To: Lindsay McGavin
From: Denise Galle
Subject: Development Application DA09/0635.07 - amendment to development consent DA09/0635 warehouse with partial demolition of existing factory and retention of offices and amenities at Lot 2 DP 619871, No. 35-37 Morton Street Chinderah
Reference: DA09/0635.07

S96 Modification Assessment Report

Section 96 Application DA09/0635.07 - amendment to development consent DA09/0635 warehouse with partial demolition of existing factory and retention of offices and amenities at Lot 2 DP 619871 No. 35-37 Morton Street Chinderah

4 Section D - Weighbridge detail 1:20

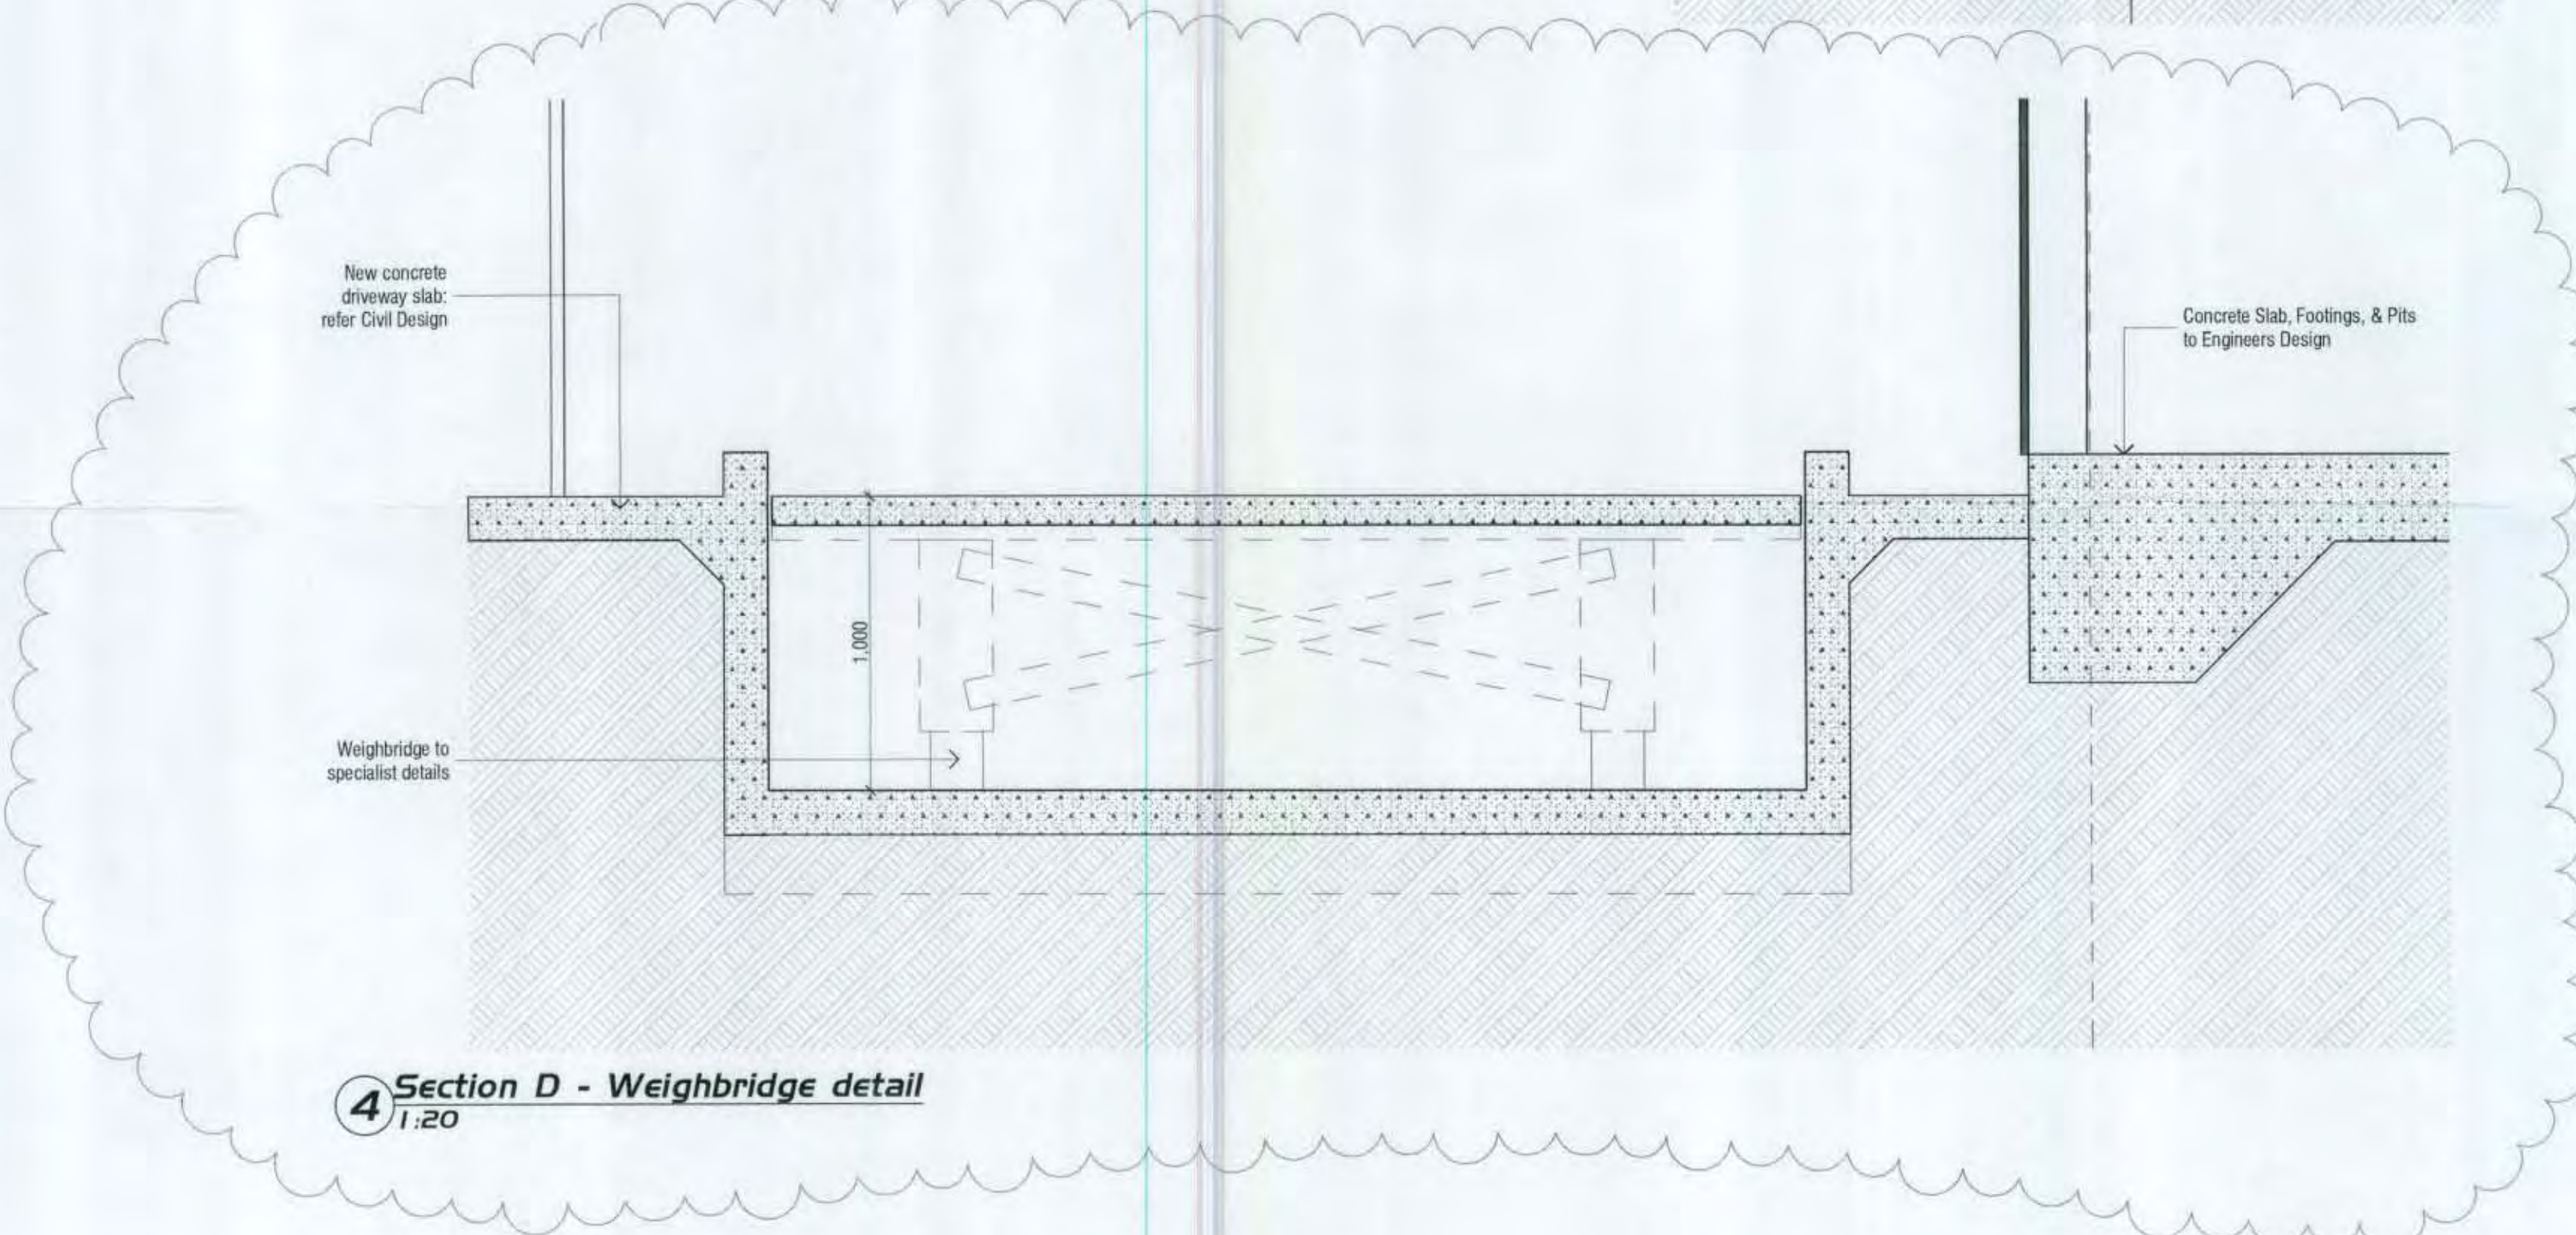
1. *Two (2) internal pits of 1.2m depth;*
2. *The provision of a transformer and pad adjacent to the Morton Street frontage;*
3. *The installation of a weighbridge between the building and western property boundary including a third pit of 1m deep;*
4. *Realignment of plan Grid A 500mm towards the northern boundary with corresponding 500mm reduction between Grid A & B (note overall building length and setbacks have not altered);*
5. *Minor amendment the to north elevation, through the relocation of small 1.2m by 1.2m precast opening (refer highlighted area on drawing WD20.1)*

- 1295-WD40.1 Issue D – Details (weighbridge), prepared by Lightwave Architecture and dated 18 May 2010,
- except where varied by the conditions of this consent.
